**SPRINGFIELD TOWNSHIP
APPLICATION FOR
SUBDIVISION AND LAND DEVELOPMENT APPROVAL**

Reference: 40 / 42 Grove Avenue – Subdivision

**LOT LINE ADJUSTMENT PLAN
PREPARED FOR
40 GROVE AVE. LLC & 42 GROVE AVE. LLC**
Situate In:
**The Township of Springfield
Montgomery County, Pennsylvania**

Reference: 310 Roesch Avenue – PECO Driver Training Center

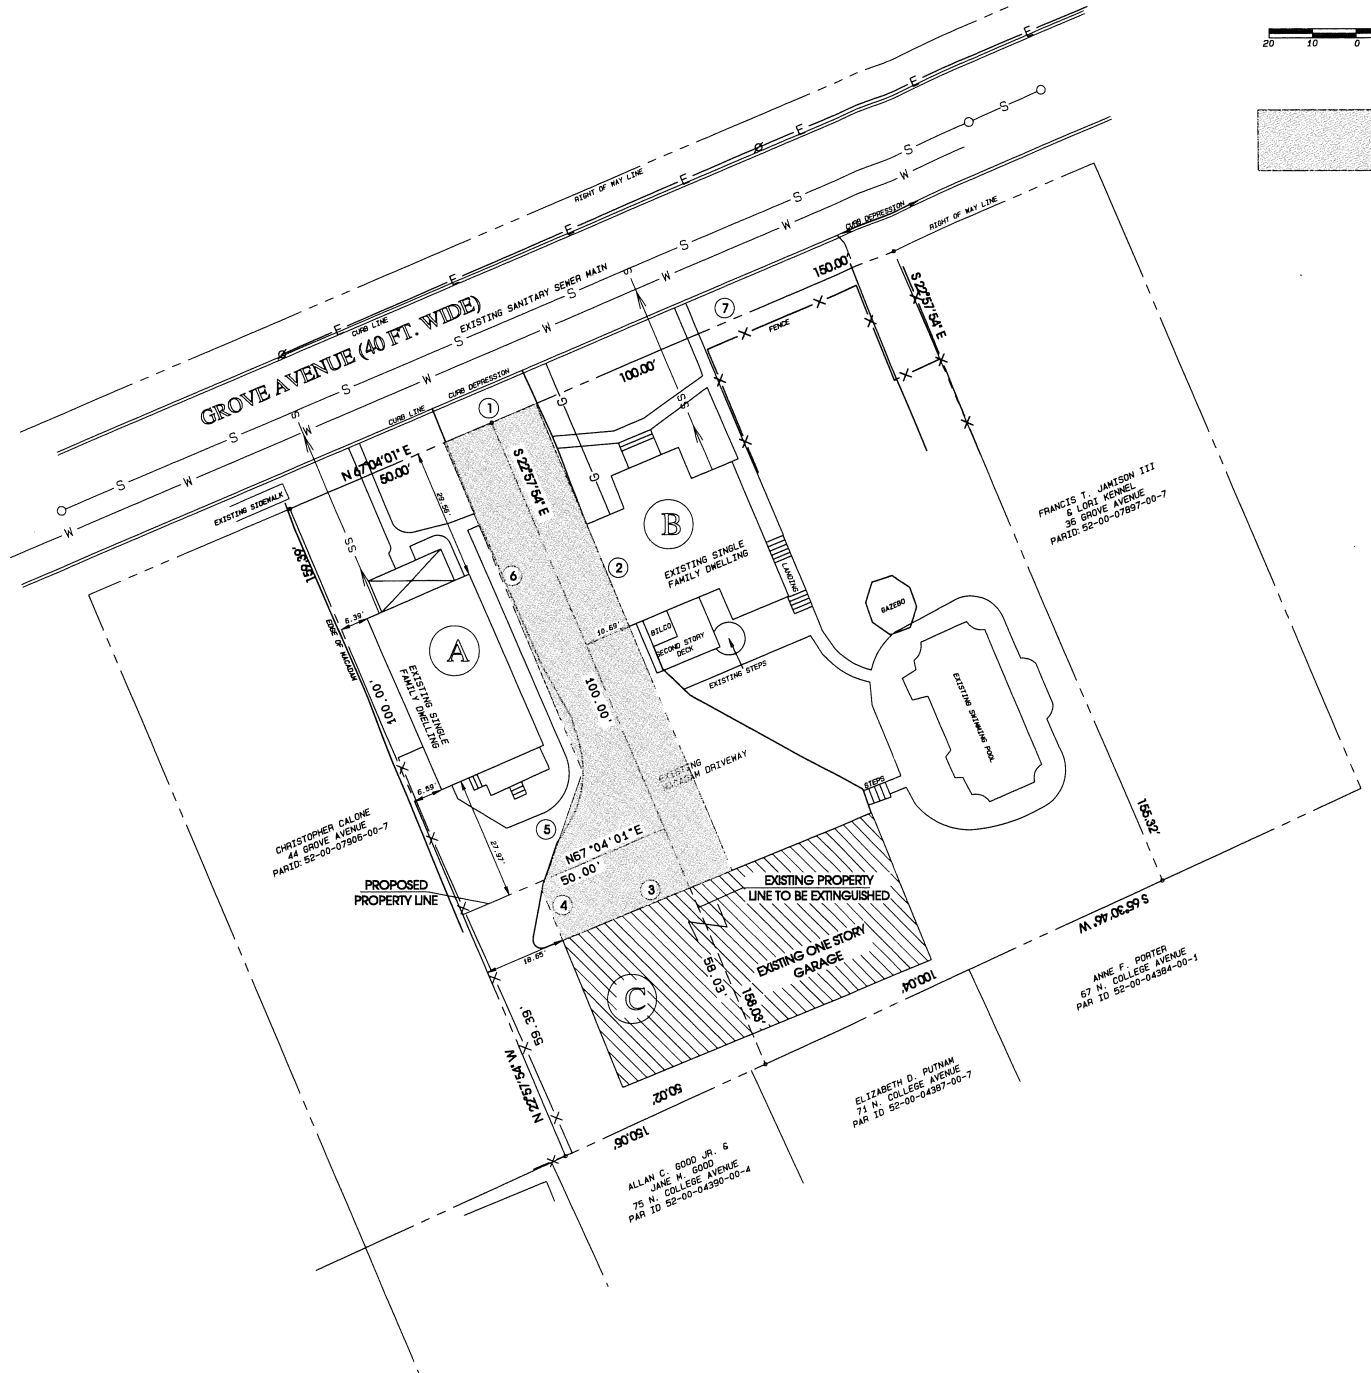
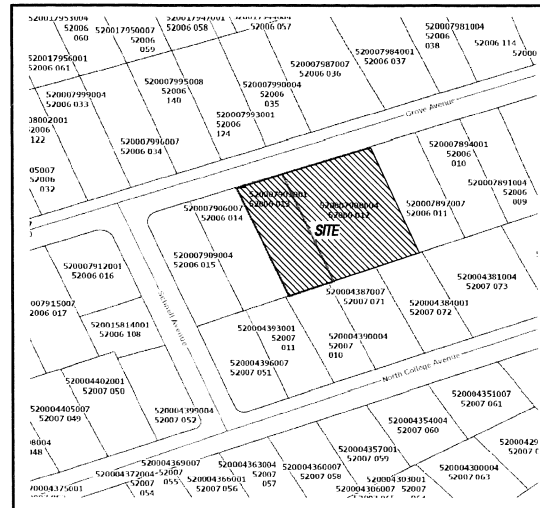
1. Section 114-34.A(1) – Any dwelling is required to be provided with two parking spaces. The plan must clearly show how the two parking spaces will be provided for the dwelling at 40 Grove Avenue.

1. Section 95-7.B – the location of all street monuments and property corners must be shown on the plan.
2. Section 95-.F – The location of all utilities must be shown on the plan. Of particular concern are any utilities that may run beneath the existing driveway providing water, cable-TV, gas, etc. to ensure that the cross-access easement agreement deals with these utilities and their repair and replacement.
3. Section 95-10.A – A residential street is required to be fitted with a 50 foot right-of-way, a 30 foot cartway, curbs and sidewalks.
4. Section 95-10.I – Concrete sidewalks not less than four feet in width shall be provided on any street or road which is residential in character.

5. Section 95-11.H – Survey monumentation is required to delineate the existing and proposed property corners.

The Township solicitor's office must review and approve the formal terms of a cross access easement agreement. While all obligations for maintenance, repair, and access will fall to the eventual property owners, the Township must be sure that appropriate provisions exist to account for a number of possible scenarios. Scenarios include blocking of the driveway, repaving, snow removal; of particular note is the fact that physical access to the western garage bay is significantly encumbered by the resultant property line configuration. This condition must be addressed not only in the agreement but on the plan.

A dimension must be added to the plan from the proposed rear lot line of 40 Grove Avenue to the front face of the existing garage.

The plan must label lots depicted as A & B with their actual street addresses.

The width of the existing driveway must be shown on the plans.

The existing side yard setback from the structure on the lot labeled 'A' to the existing boundary line must be dimensioned on the plans.

The existing rear yard setback from property boundary to the garage must be labeled on the plans.

There appears to be fence encroachment from the property at 44 Grove Avenue onto the properties at 40 and 42 Grove Avenue. This fence encroachment must be quieted.
